*TOLEDO CITY  
PLAN COMMISSION  
REPORT*

*December 4, 2014*

**TOLEDO-LUCAS COUNTY PLAN COMMISSIONS  
APPLICATION DEADLINE, AGENDA, STAFF REPORT AND HEARING  
SCHEDULE - 2015**

# ELEVATIONS

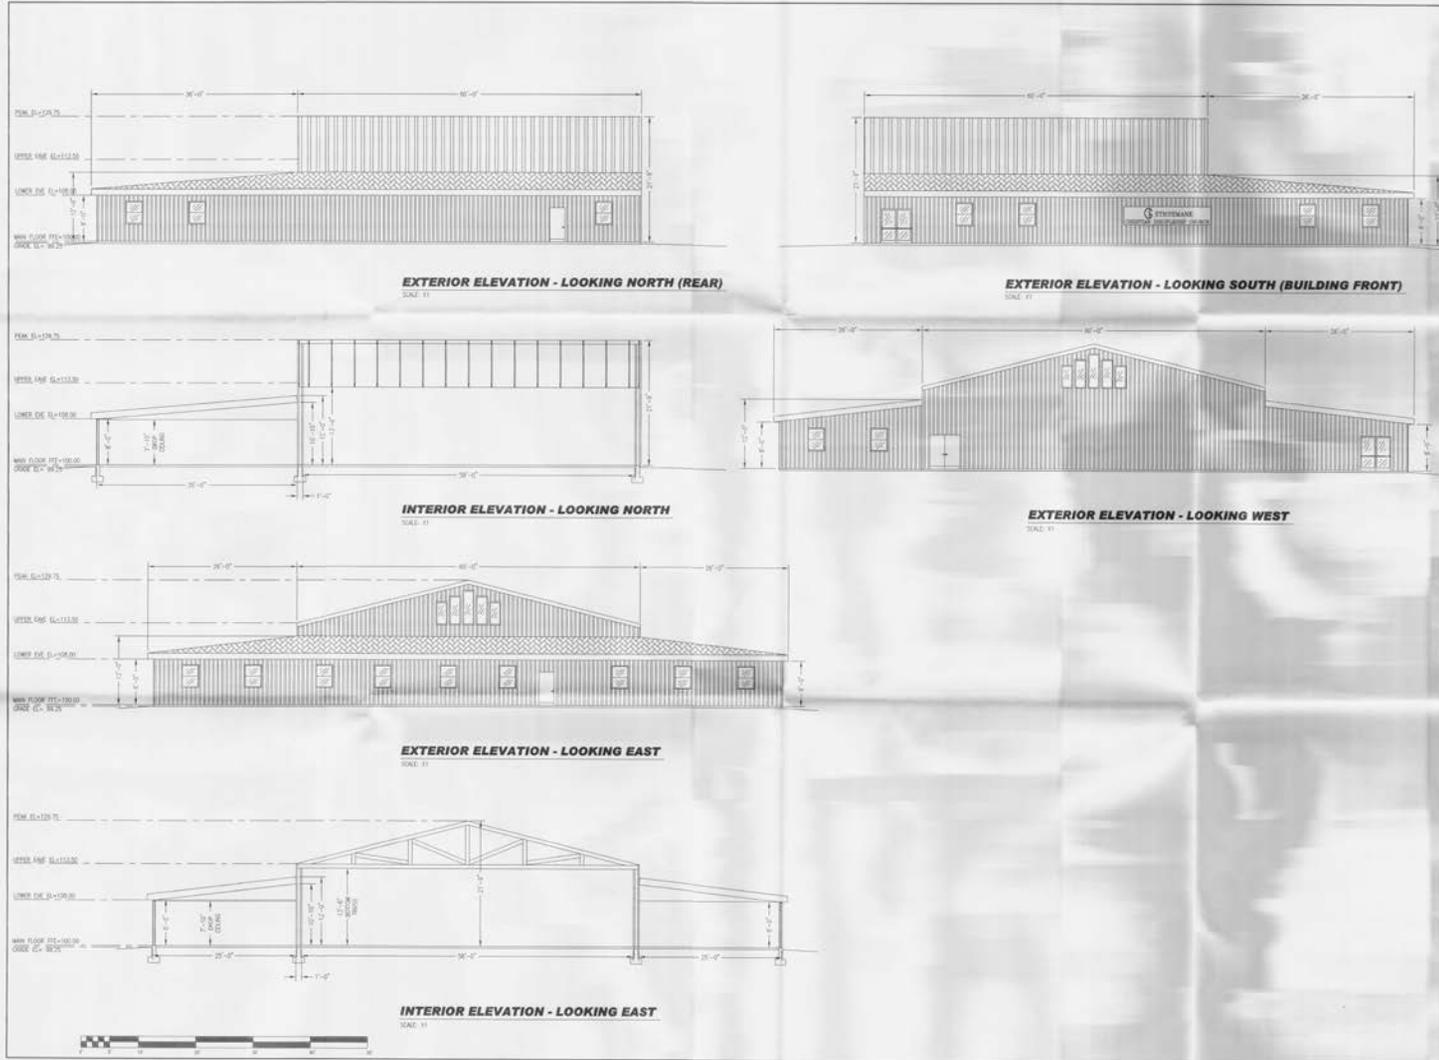
Exterior facades shall be articulated in order to add architectural interest and variety and avoid the effect of a single, long or massive wall with no relations to human size (TMC§1109.0205(C)(1) – *Design Standards*). The proposed structure is set back ±193 feet from the property line. This produces a perspective that reduces massing of the building from the right-of-way and relate to pedestrian and vehicular travel. Elevation drawings submitted depict a building that is +21 feet at the highest peak. The main entrance is located on the north façade where the roof slopes down to 8 feet and relates to human scale. Variation in roof heights and change in roofing material are also used to express internal function.

Building elevations shall comply with TMC§1109.0500 – *Façade Materials*. Predominant exterior building materials shall be high-quality materials. For facades visible from the public right-of-way, predominate materials must comprise at least seventy-five percent (75%) of the total wall area of the façade. Façade colors shall be low-reflectance, subtle, neutral or earth tone colors. Building trim and accent areas may feature brighter colors, including colors subject to the approval of the Planning Director. Building materials and colors are not clearly defined and a revised elevation drawing identifying said building attributes shall be submitted to determine compliance.
